PLANNING BOARD

Tuesday, May 23, 2023 at 5:00 PM
Via Zoom

465 Congress Street
Major Site Plan | Inclusionary Zoning
PL-002411-2023
CTR Congress, LLC

Submitted to:	Portland Planning Board	Prepared By:	Austen Torres Davis
Public Hearing Date:	May 23, 2023	Date:	May 19, 2023

DRAWING NUMBER
C4.3

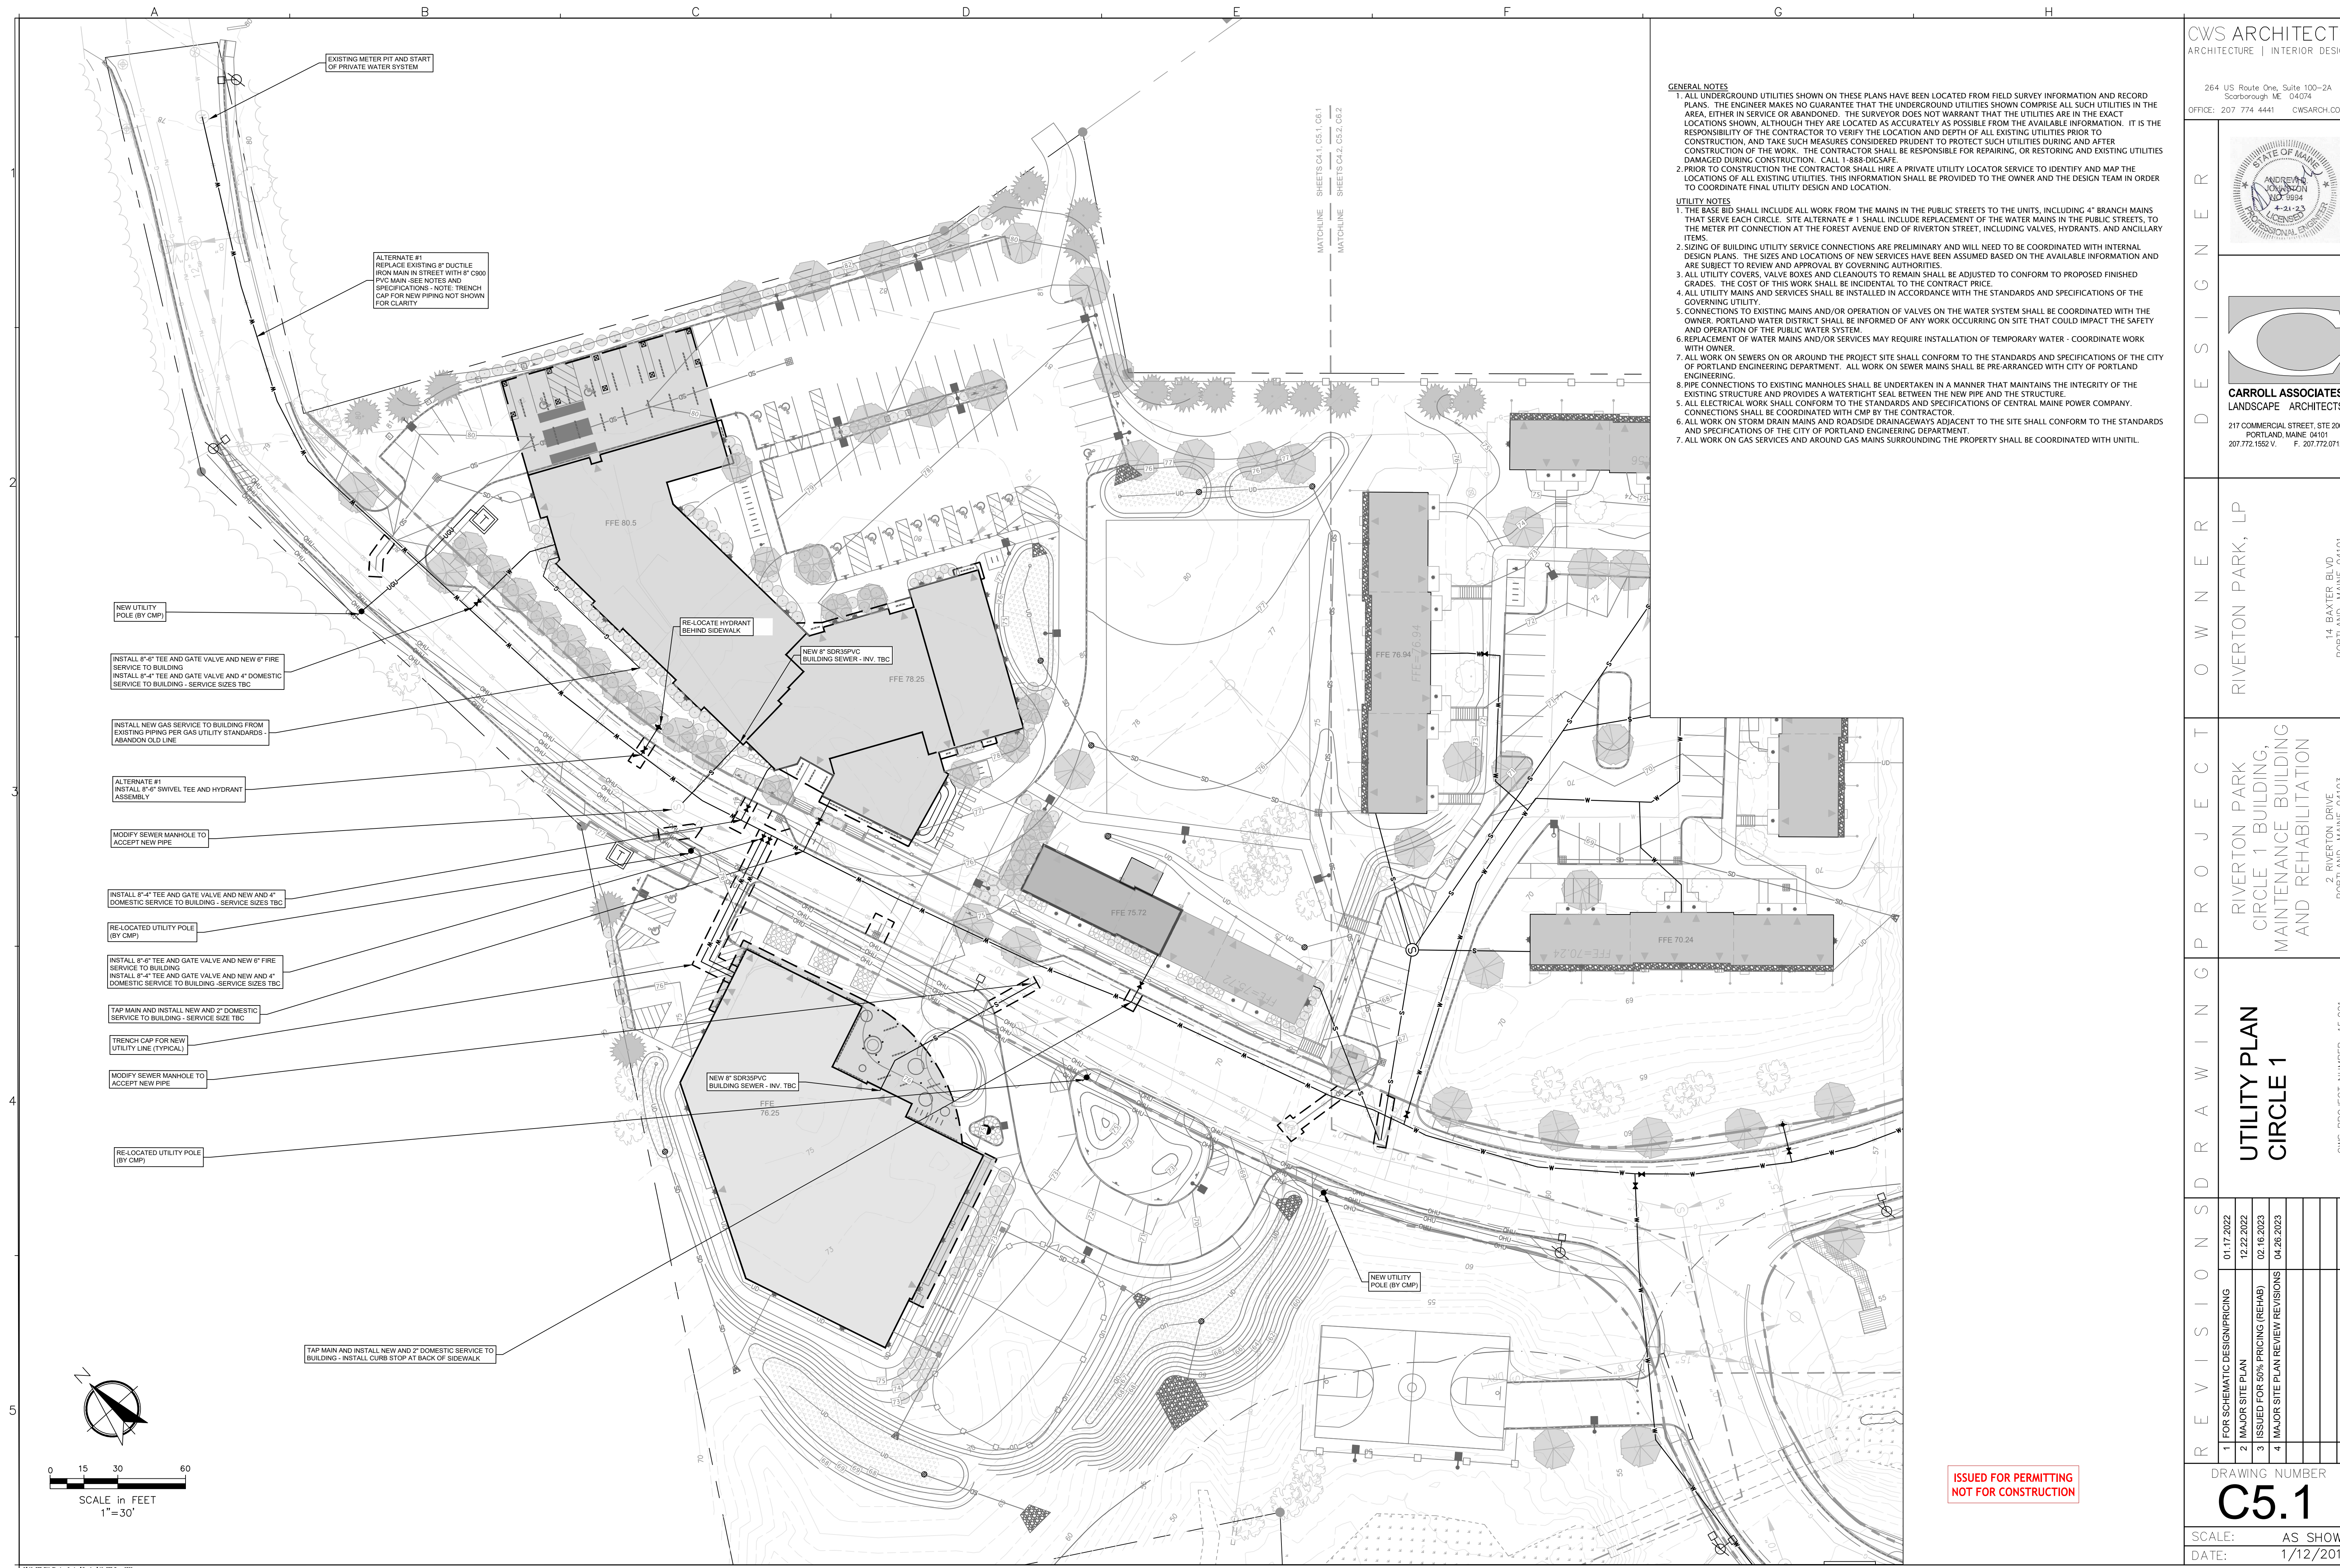
• *Stream and wetland setbacks shall be shown on grading and drainage plan C4.1 and C4.3 for further review.*

DRAWING NUMBER
C1.0

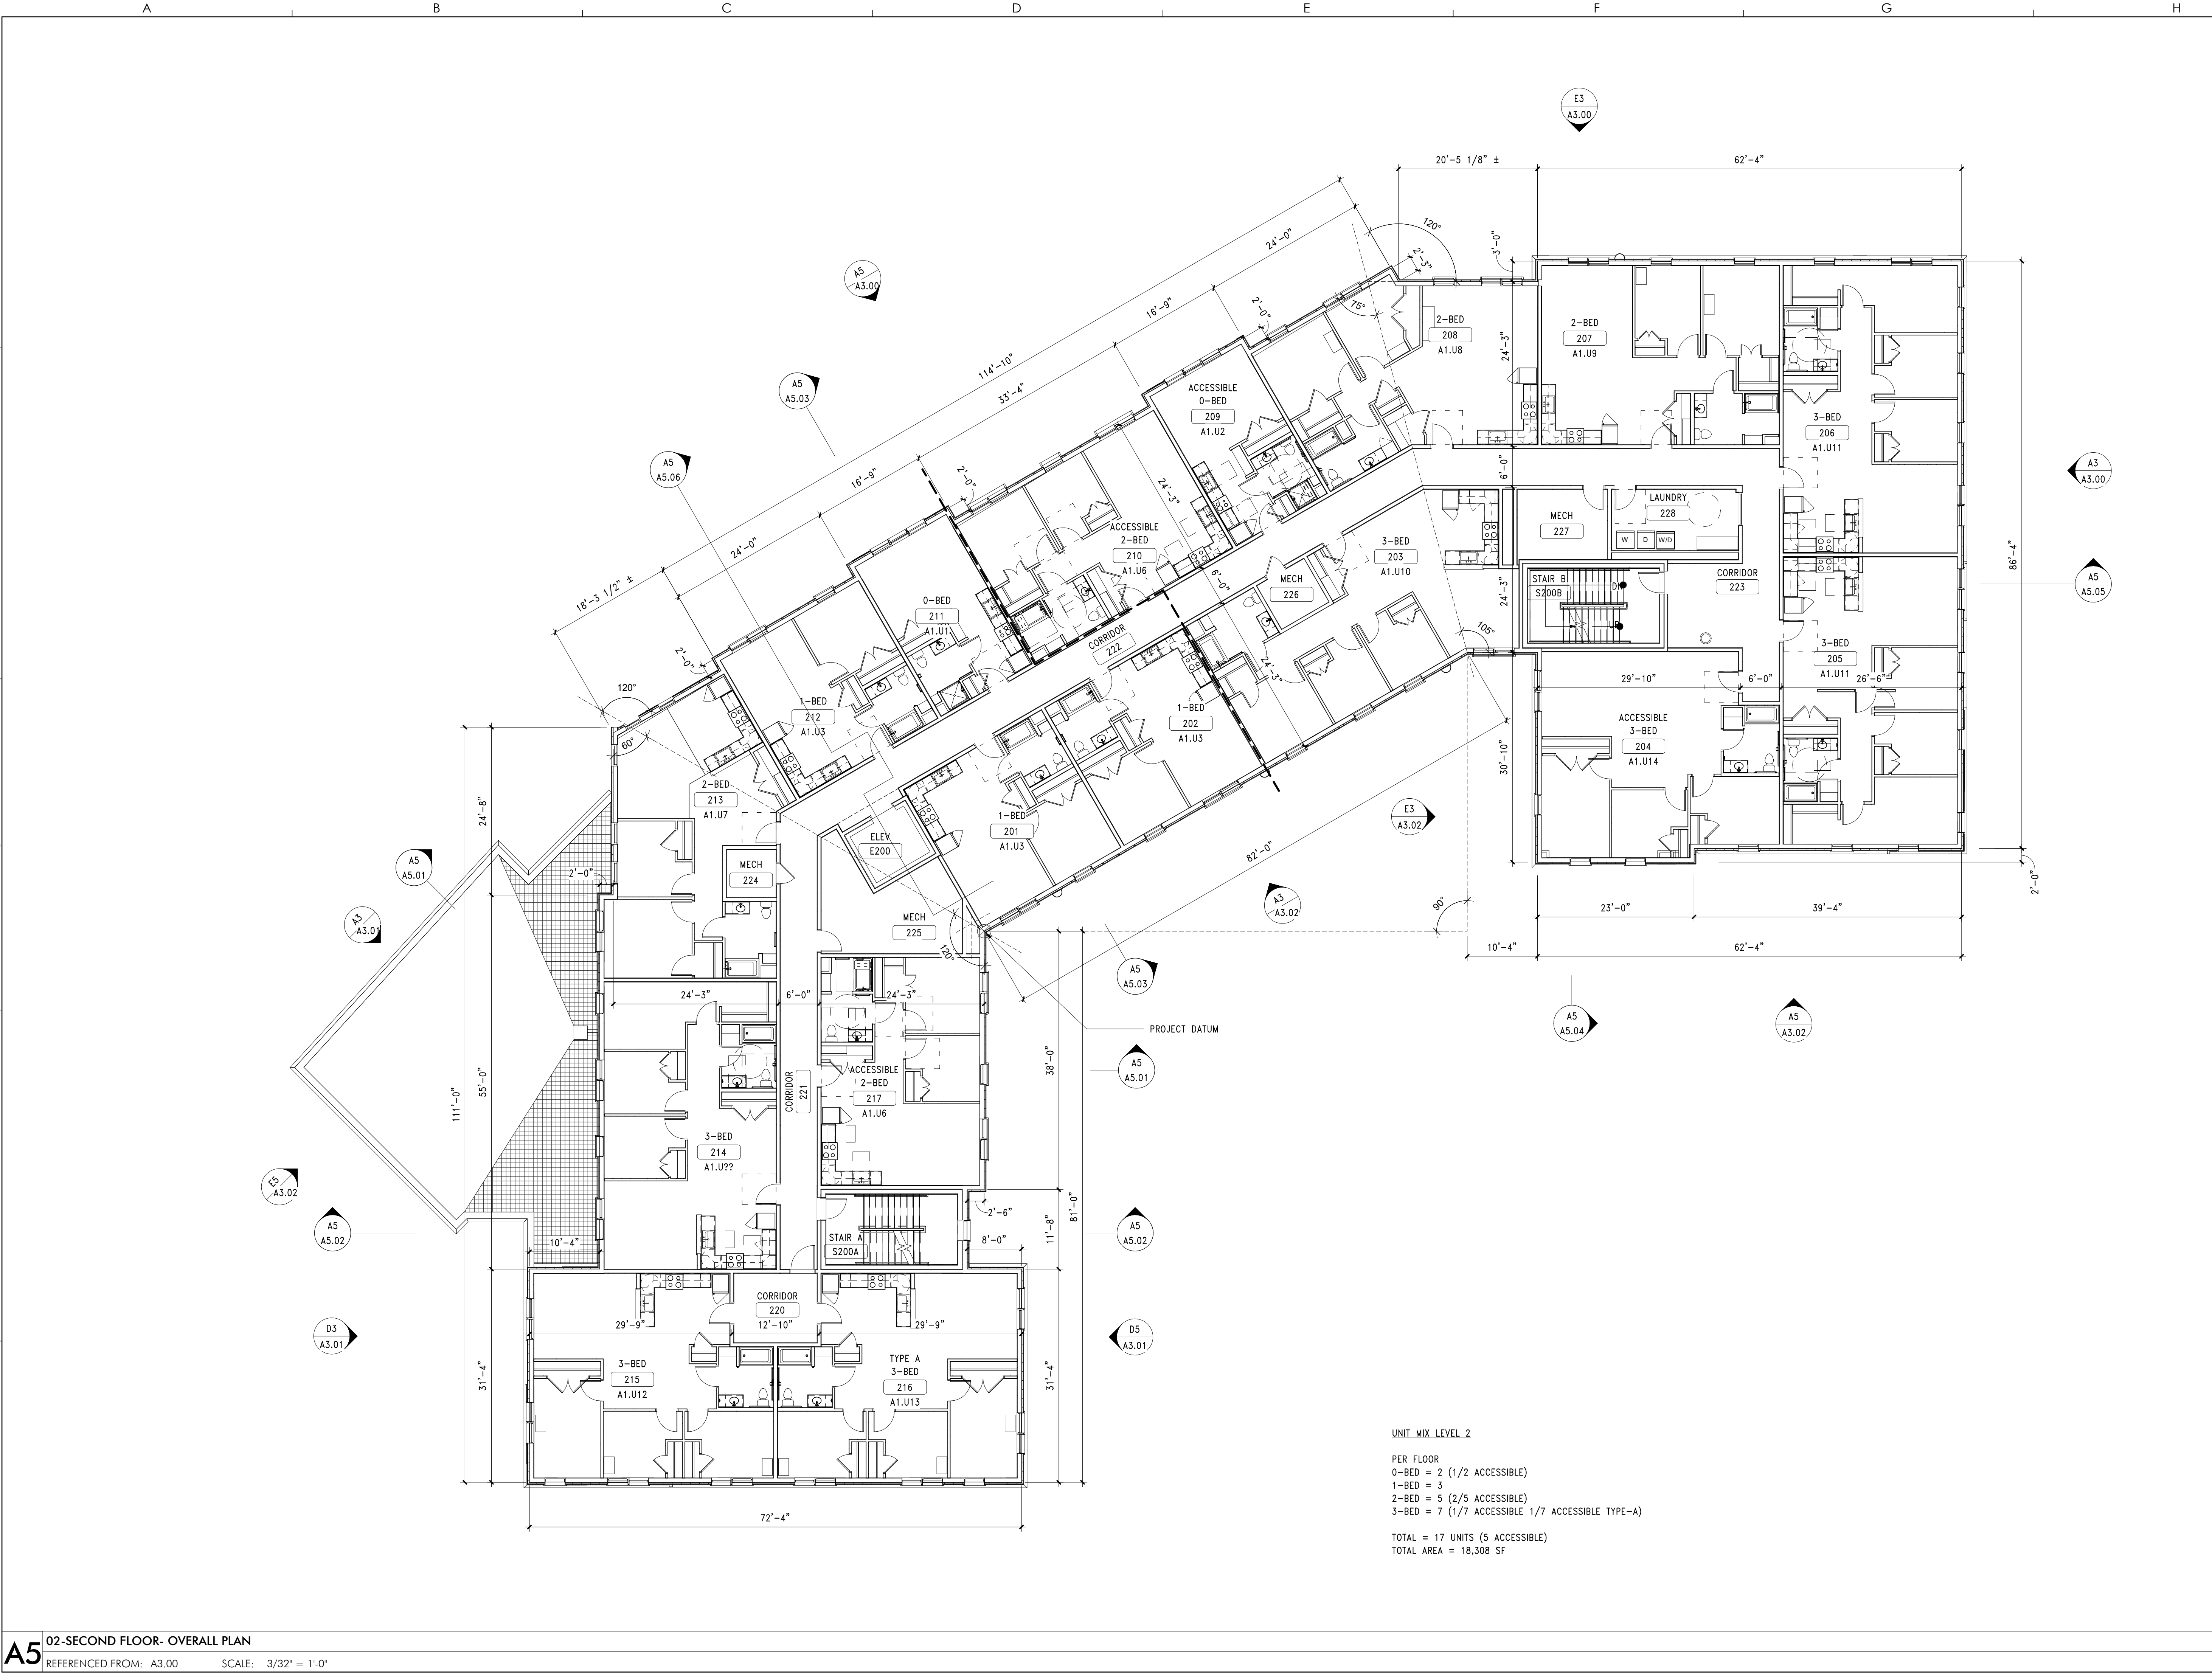
- Site renovations demarcates green areas on C1.0 Master Plan, applicant shall indicate the proposed open space program to meet design standards for recreation and open space for PRUDs in R-5a Residential zone.

- *The applicant shall clarify open space program for green spaces shown on C1.0 Master Plan. Consideration for shade and sun exposure for any areas where community gardens are being proposed. Some locations identified for community gardens are likely to be shaded by adjacent buildings. City staff recommend where grades allow, consider connecting programmed outdoor spaces with pedestrian pathways, see notes on C1.0.*

Response: Total square footage of indicated open space (26,736 SF) and square footage per dwelling unit (217 SF/DU) will be added to the Space and Bulk table on sheet C3.1 Site Plan. Open space program elements shall include: recreational field and play area behind buildings 5+6, community garden area, play area (elements TBD) and basketball court at Neighborhood Center, and numerous other unprogrammed open spaces with the other circles at the property. Also see response regarding Open Space programming in the Landscaping and Environmental Quality Section of the Response Letter. **The proposed rock-climbing feature will be relocated from the field area to the Neighborhood Center and incorporated into the playground space. Playground amenities are TBD.**

Response: The requested information is shown on sheet C1.0 Master Plan. Existing off-street parking count is 195 and proposed off-street parking count is 228 which is a net gain of 33 parking spaces.
